LA SALLE NUCLEAR POWER STATION
SITE-SPECIFIC OFFSITE RADIOLOGICAL EMERGENCY
PREPAREDNESS ALERT AND NOTIFICATION SYSTEM
QUALITY ASSURANCE VERIFICATION

Federal Emergency Management Agency
Washington, D.C. 20472
Under Contract No. EMW-83-C-1217

May 29, 1985

LA SALLE NUCLEAR ALERT AND NOTIFICATION SYSTEM ACTIVITY

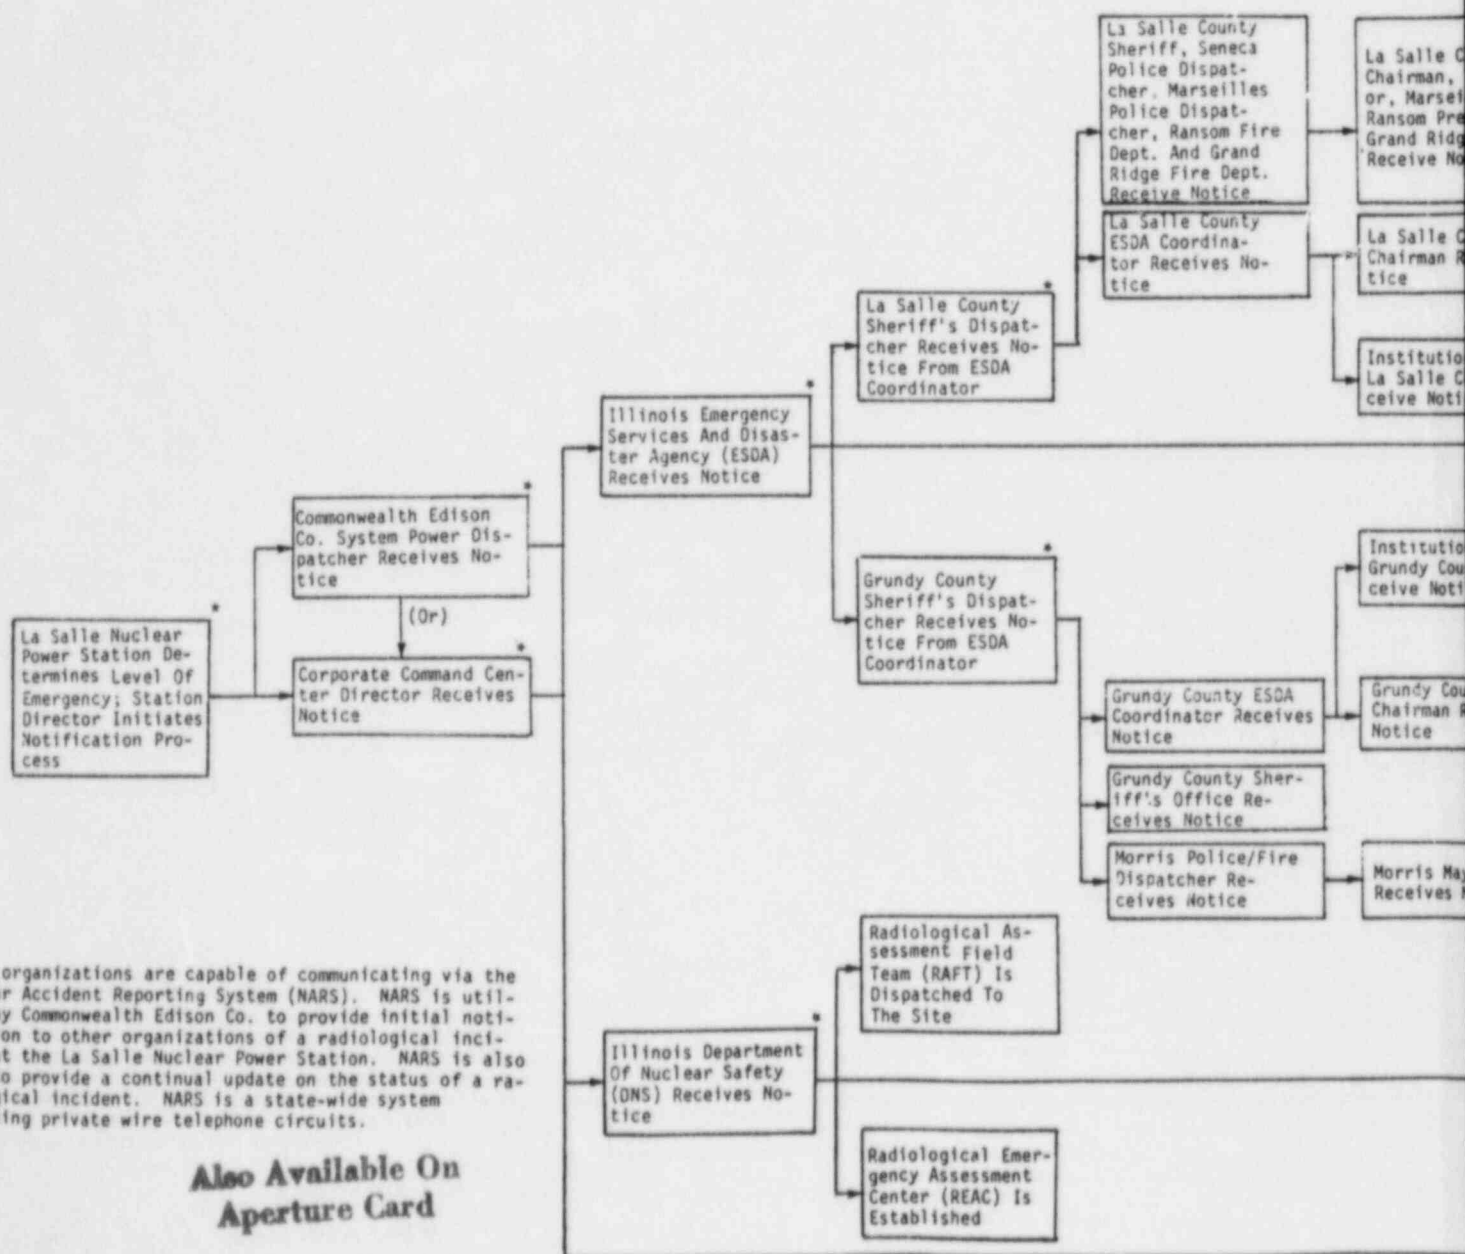
As Figure 1 indicates, these procedures satisfy FEMA-43 acceptance criteria. These current emergency procedures document the responsibilities concerning the alert and notification system activation process from the time a decision is conveyed via the Illinois Emergency Services and Disaster Agency Coordinator to the La Salle County and Grundy County Sheriffs' Dispatchers (who physically activate the sirens).

FIGURE 2
LASALLE SIREN CONTOUR PLOT

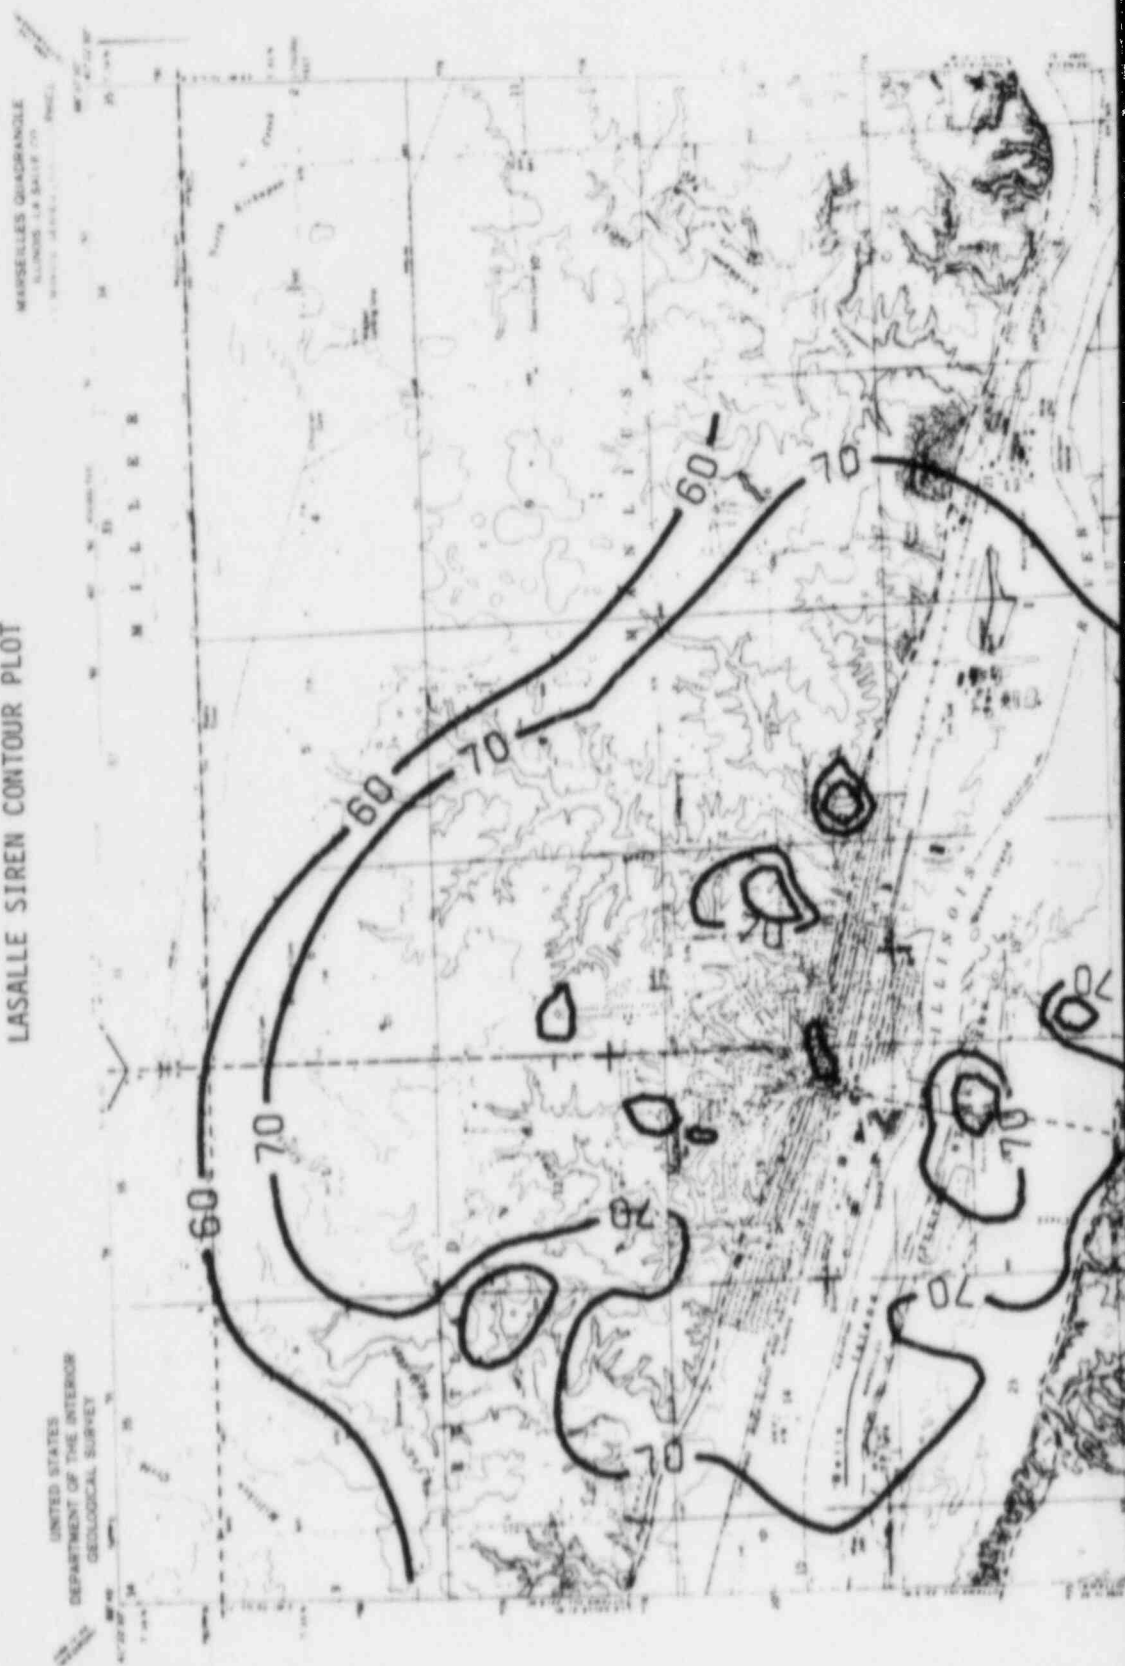
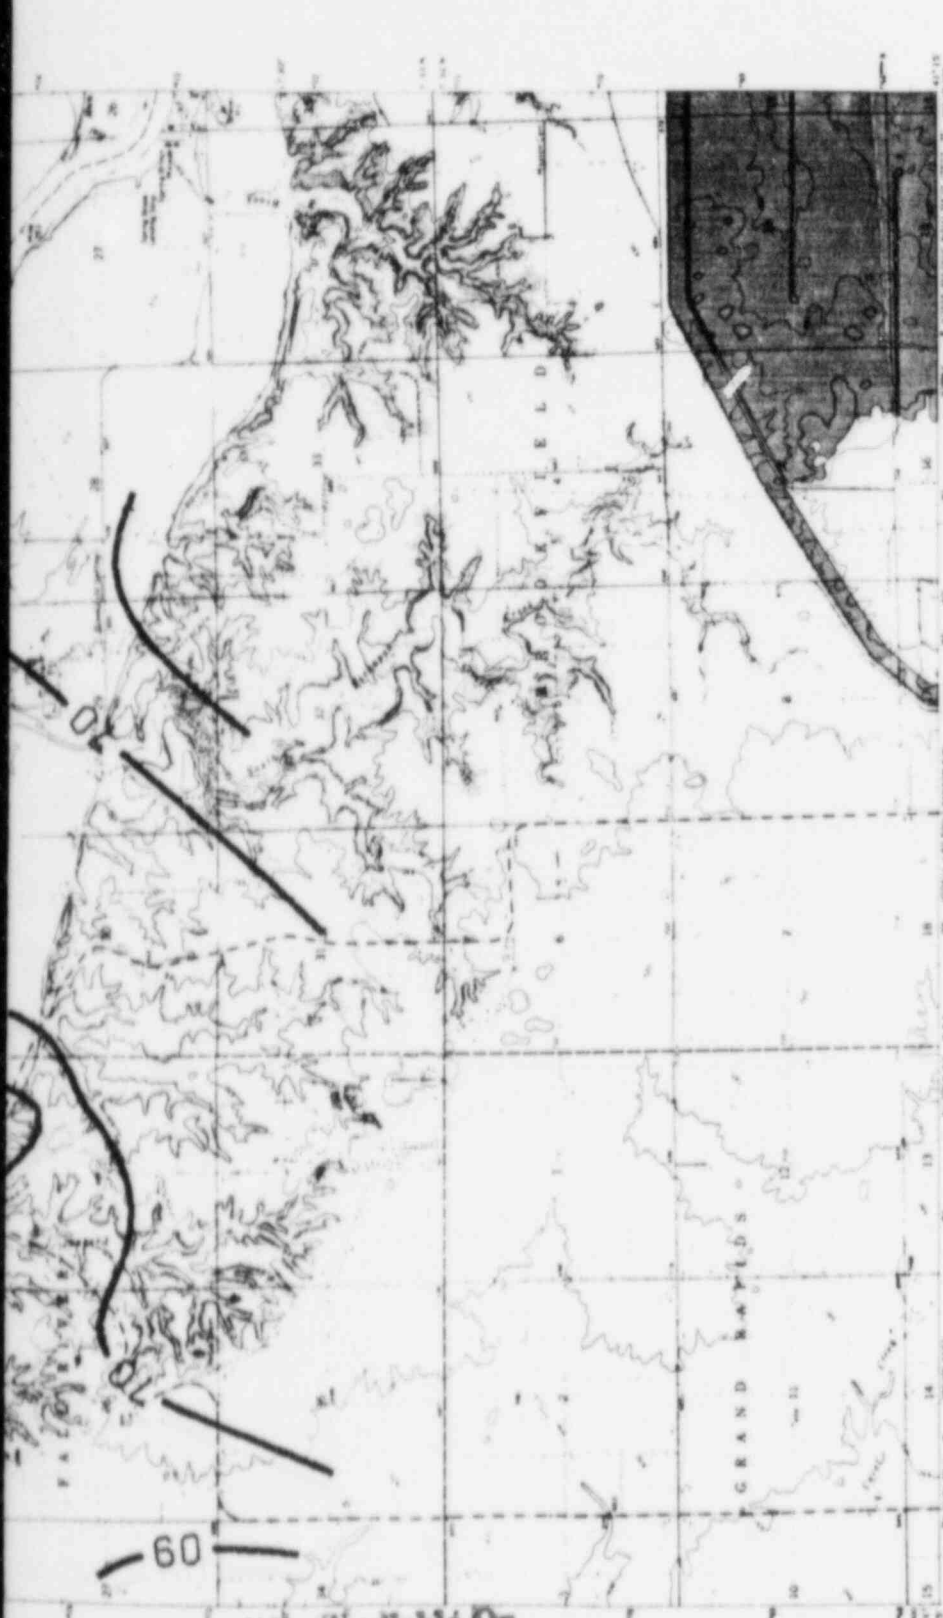
The results of the individual OSPM runs were combined to generate a comprehensive overview of the siren sound pressure levels over the Marseilles area. A logarithmic distance-weighted interpolation was performed on the output results of the three sirens to generate a grid of 44 by 44 dBC values over the entire map area. Each siren's dBC output was interpolated over this grid.

The maximum dBC values at each grid point were then used to compute the siren sound pressure level contours as shown in Figure 2. These contours account for the site-specific topographical and meteorological effects. Comparison of the OSPM predicted 70 dBC contours with the Design Report's 70 dBC contours indicates that the siren coverage (as discussed in the Design Report) in Marseilles is slightly more conservative than those coverages projected by OSPM.

COMPARATIVE OSPM RESULTS, HILLY TERRAIN (FS 1000 SIREN)

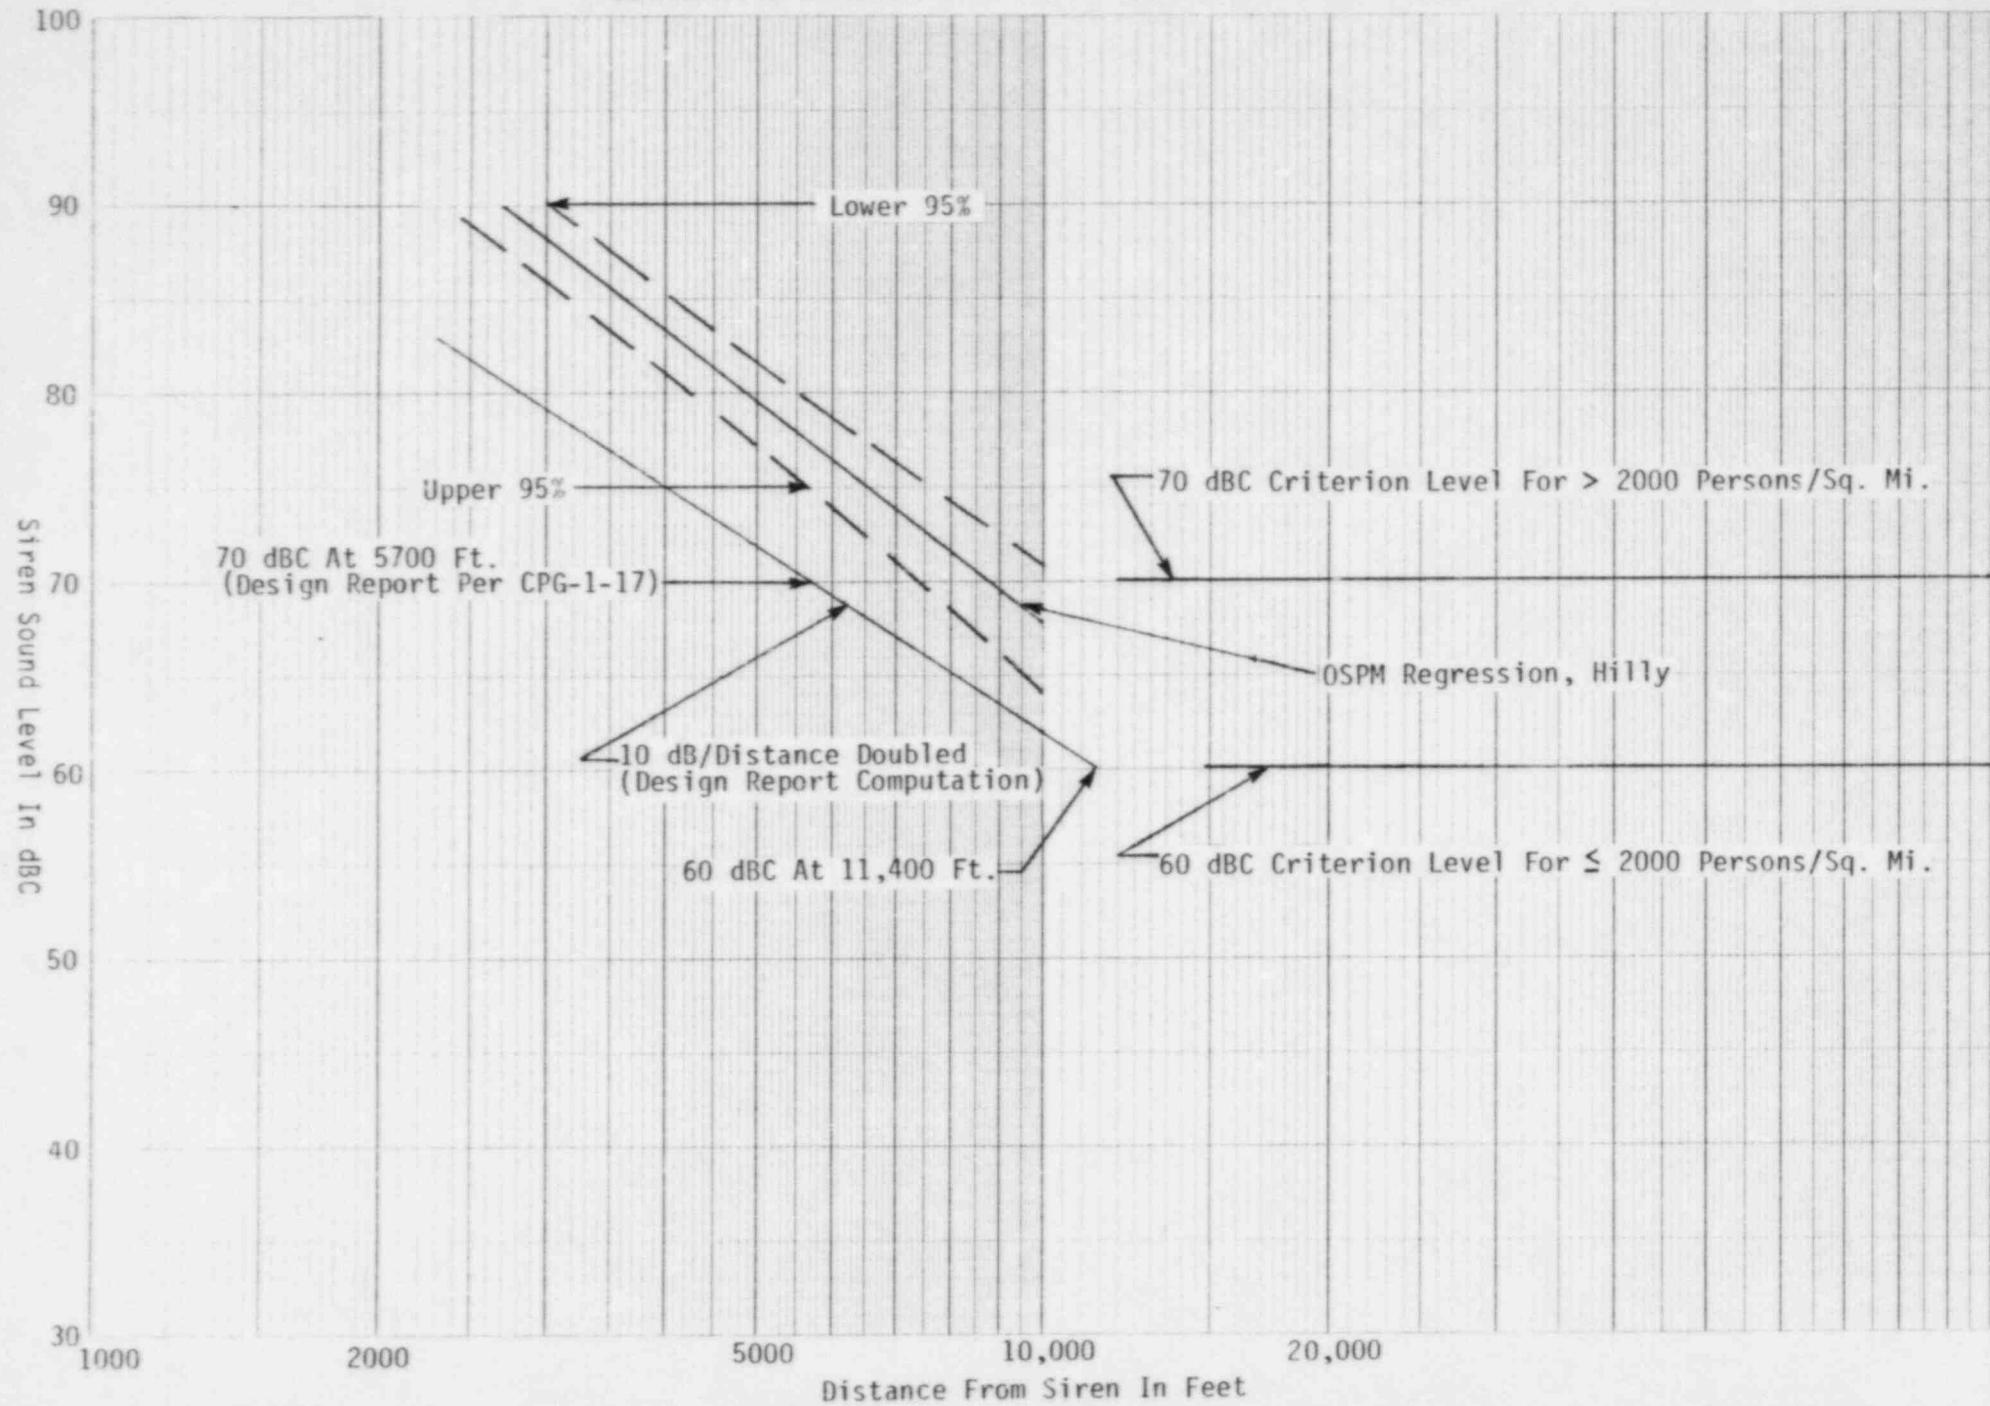
These ranges are conservative over relatively flat terrains, with the conservatism being pronounced for the 70 dBC range estimates. In addition, the range estimates that include the barrier attenuation procedure over partially hilly and hilly terrains adequately account for the site terrain characteristics.
